ADDENDUM NO. 1

RAC PARKING LOT EXPANSION

LACEY CONTRACT NO. PW 2022-19

Issued this 25th day of September, 2023.

SITE AND PAVING PLAN

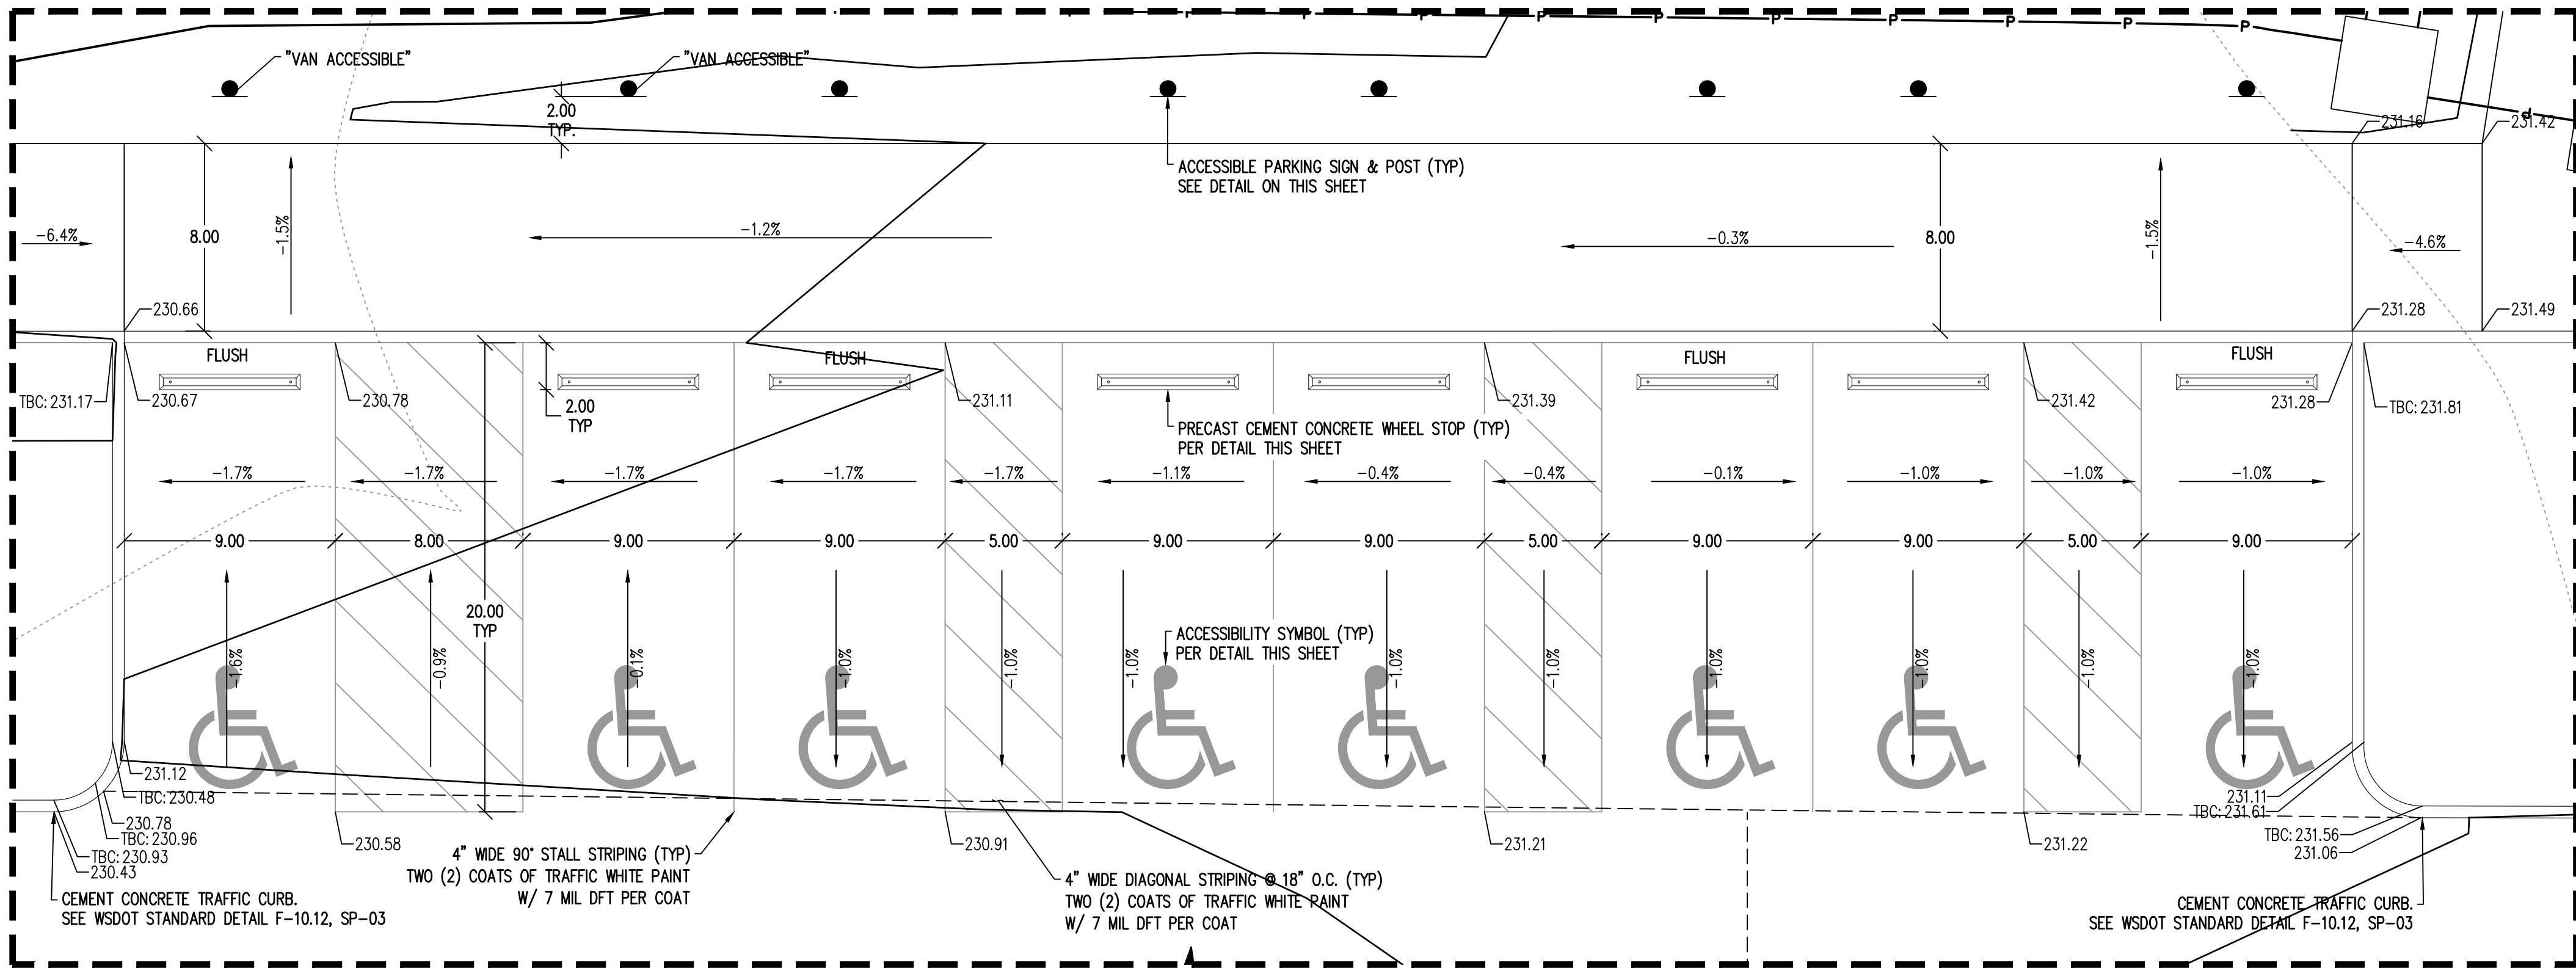
- 1) *The revisions include modifications to the driveways shown on Sheet SP-01.*

Delete Sheet SP-01 and replace it with the new page as attached.

TYPICAL ASPHALT PAVEMENT SECTIONS
NTS

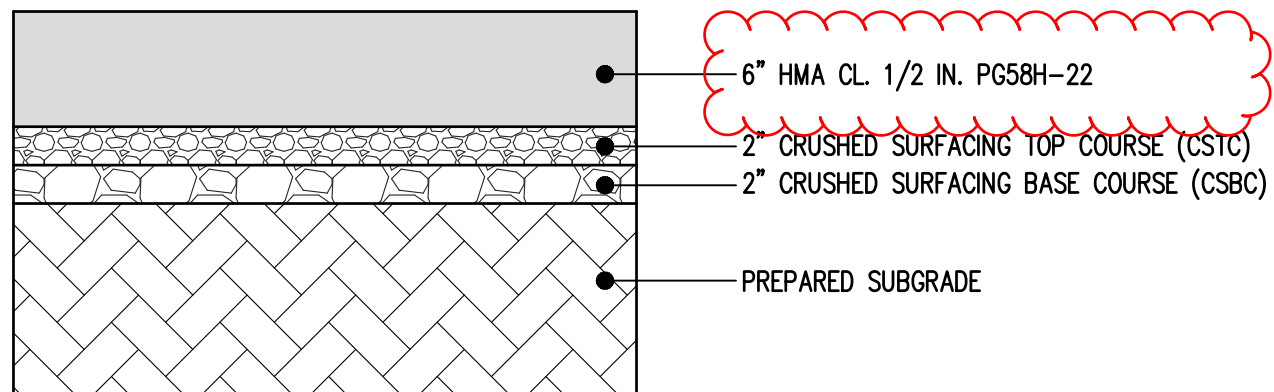
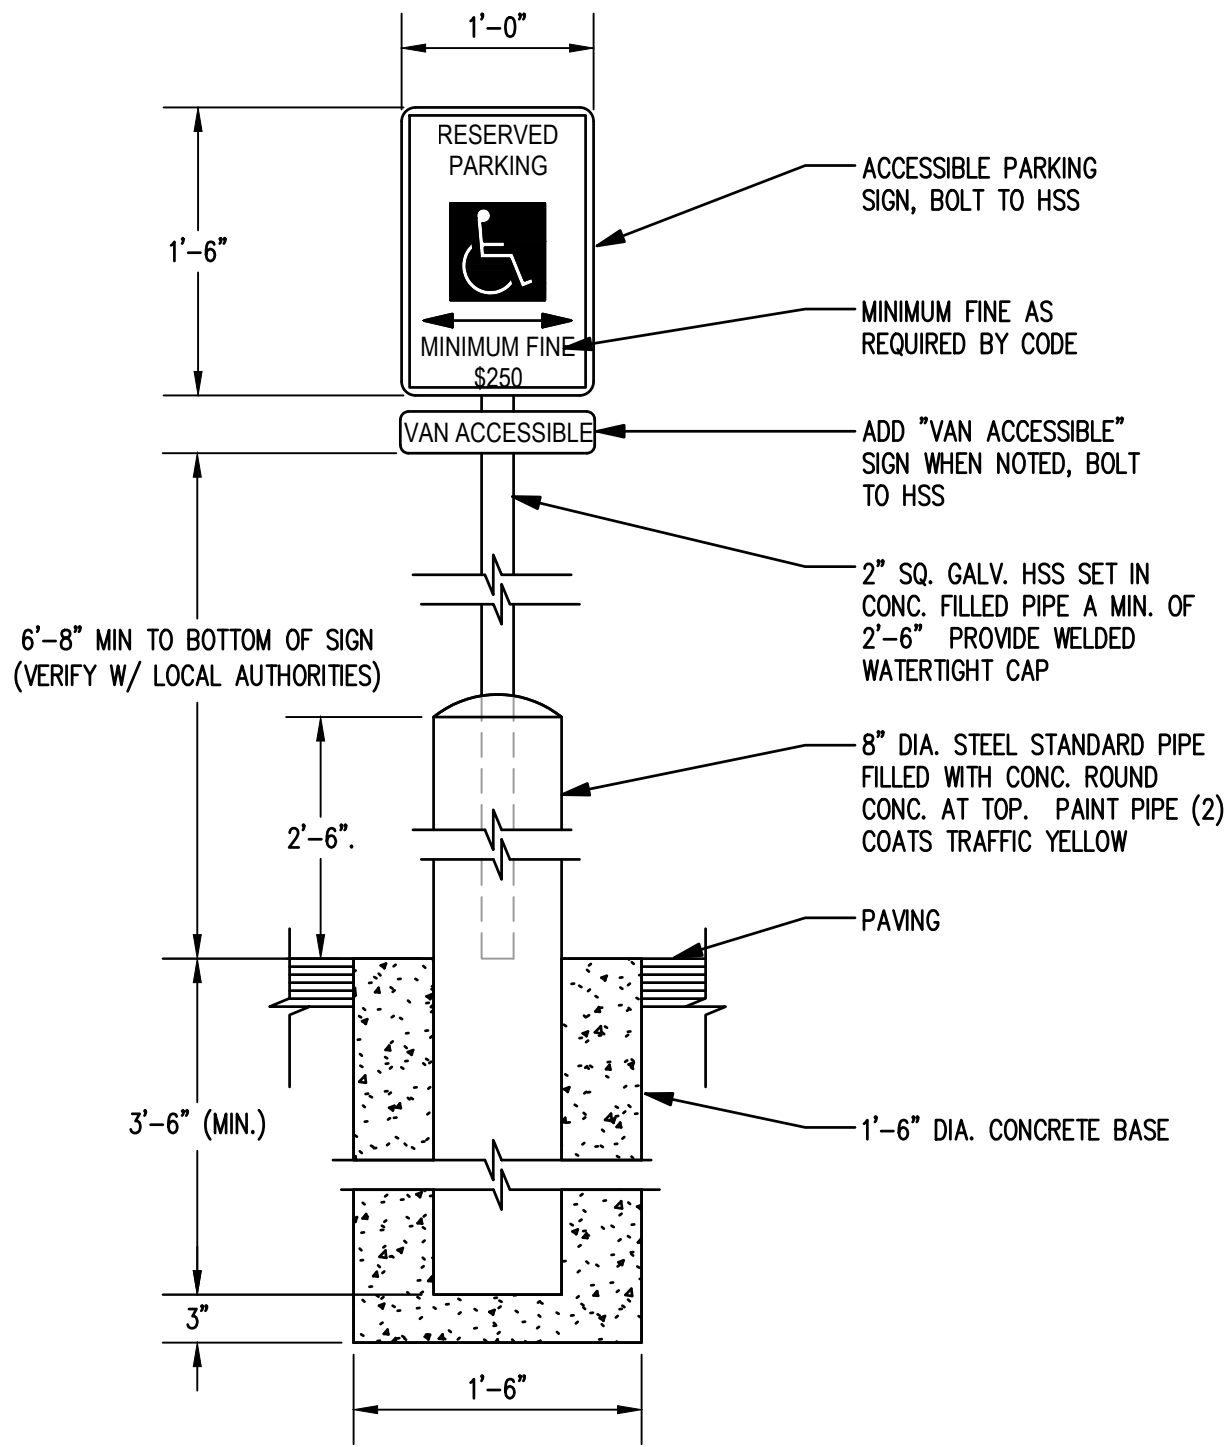
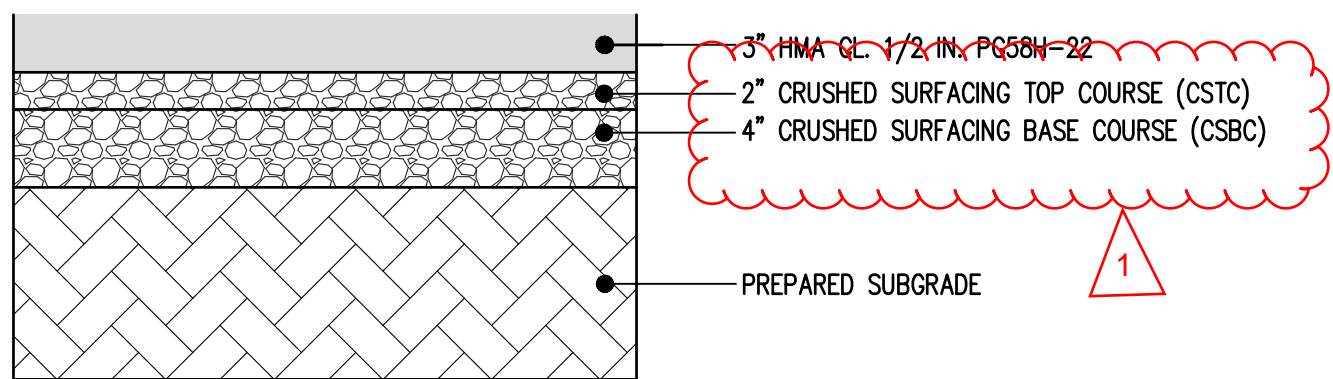
- 2) *The revisions include modifications to the paving sections on Sheet SP-02.*

Delete Sheet SP-02 and replace it with the new page as attached.

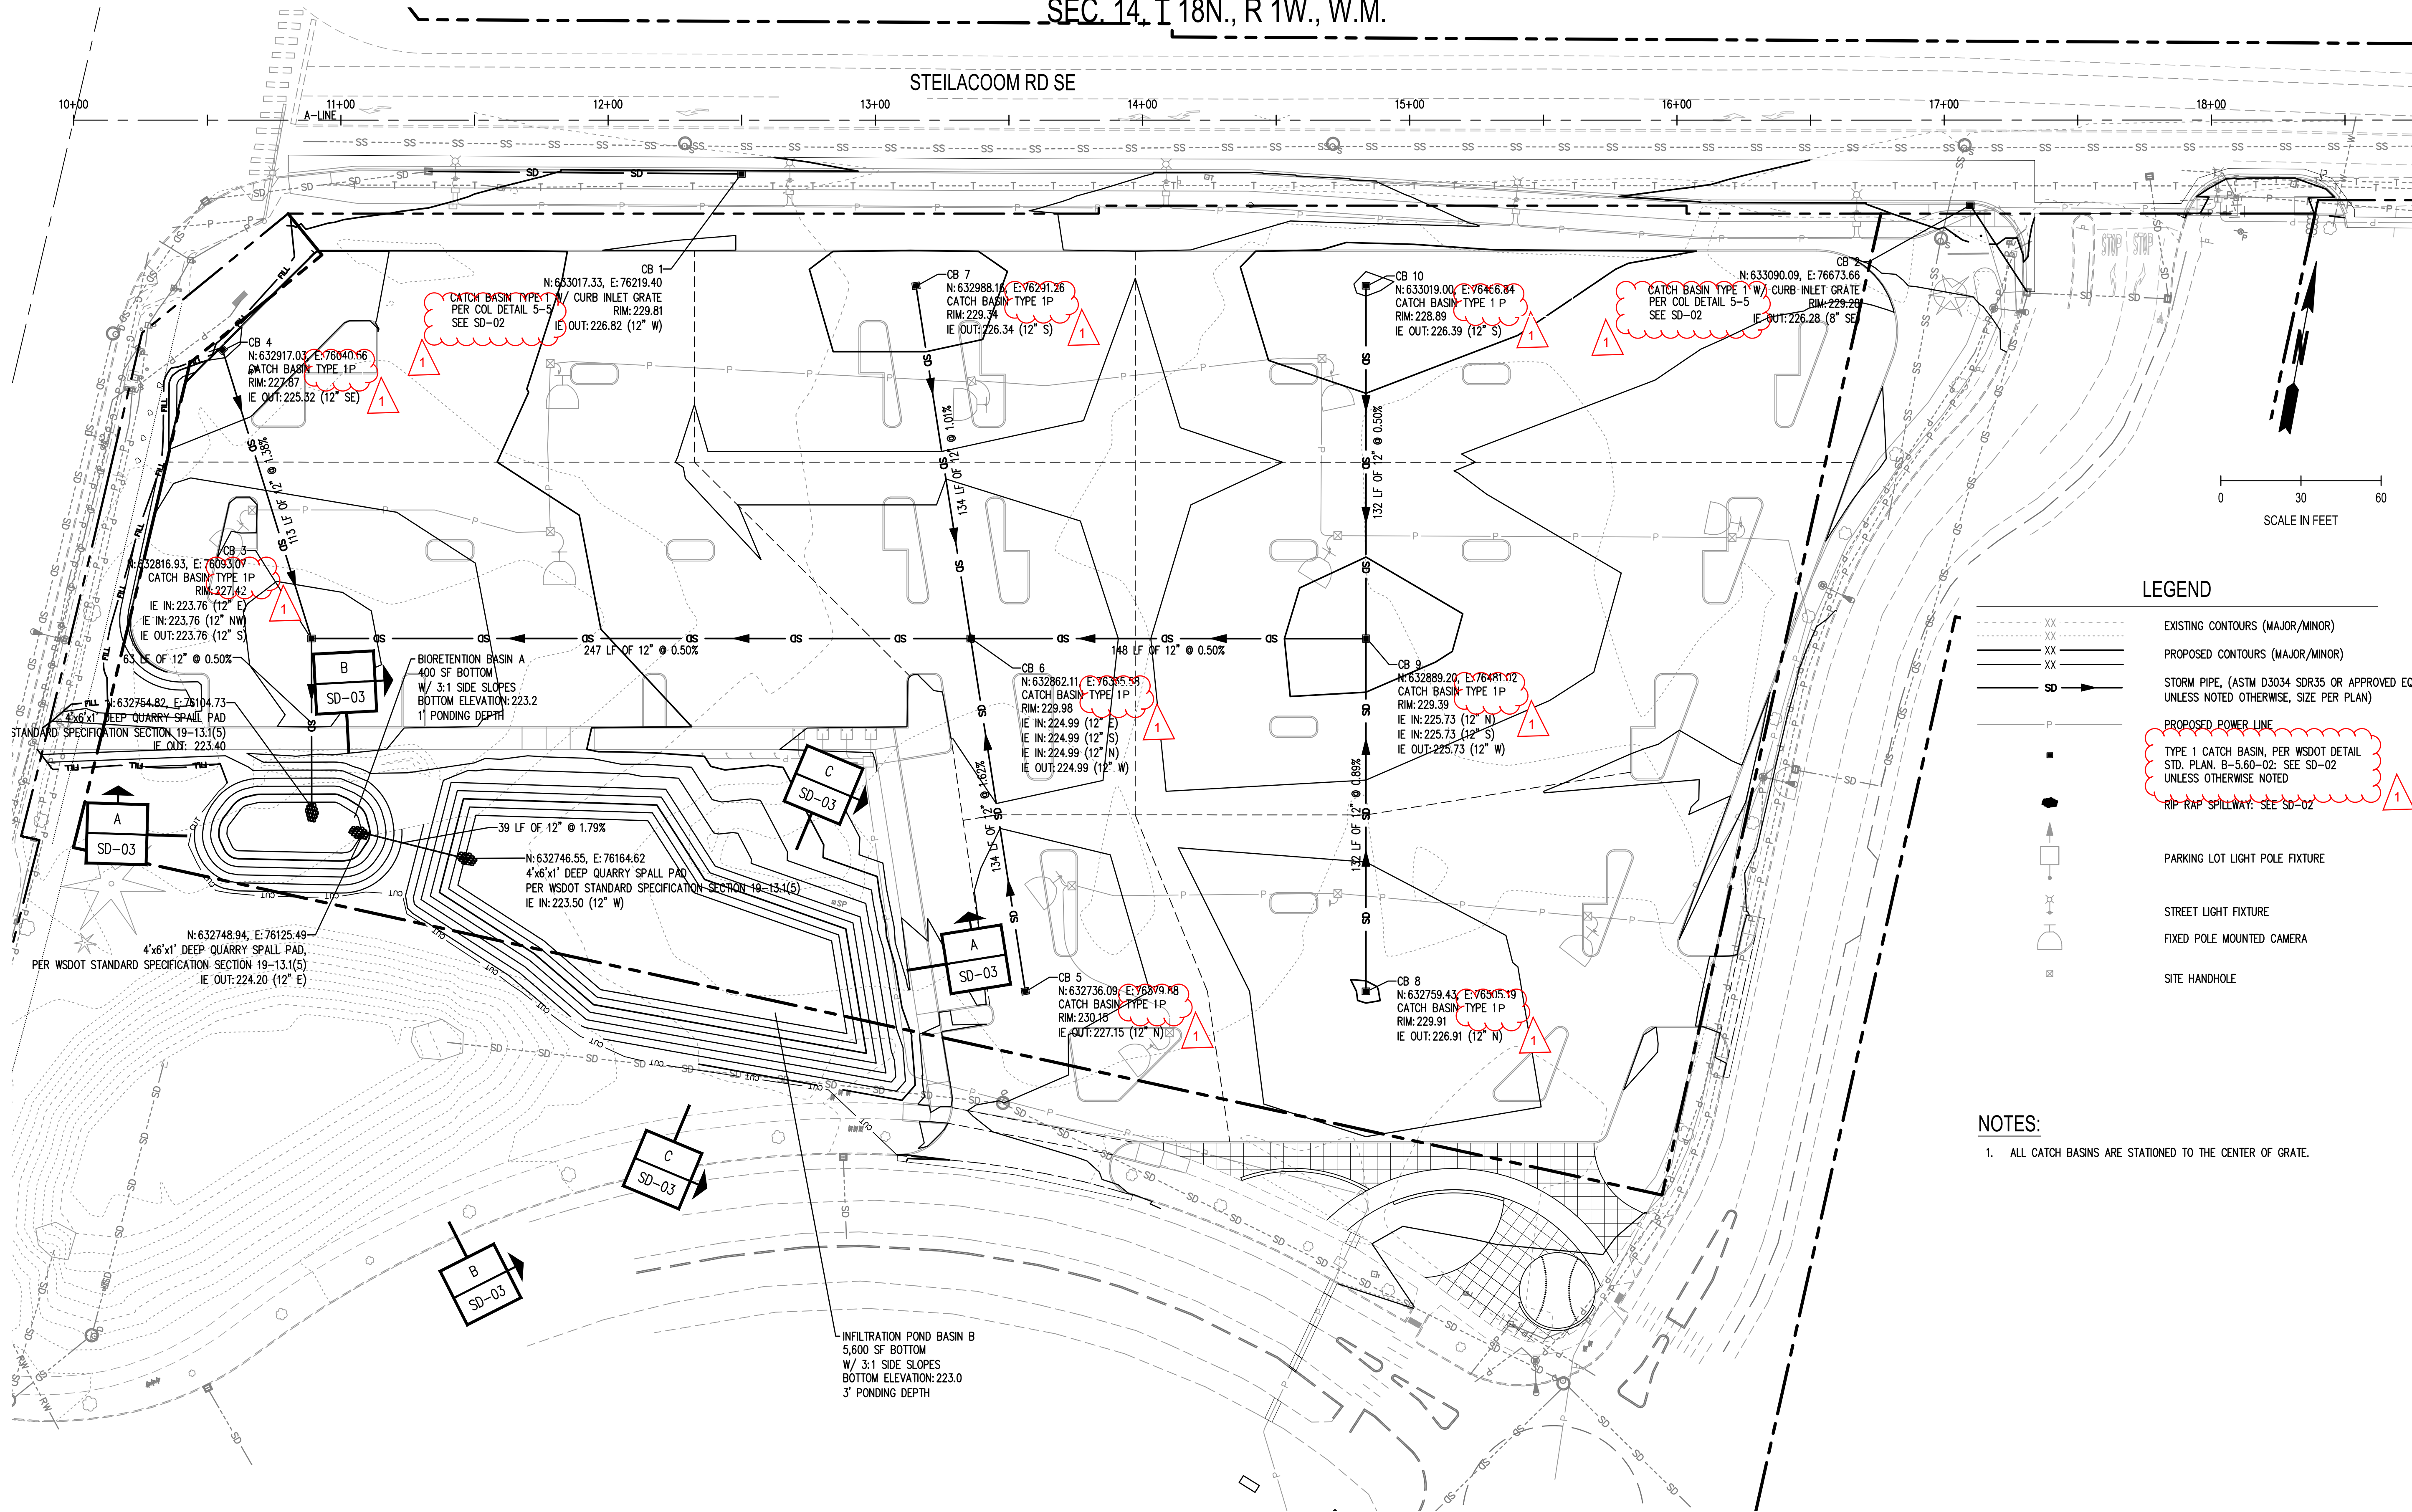
- 4) *The revisions include modifications to the notes and callouts for Catch Basins on Sheet SD-01.*

Delete Sheet SD-01 and replace it with the new page as attached.
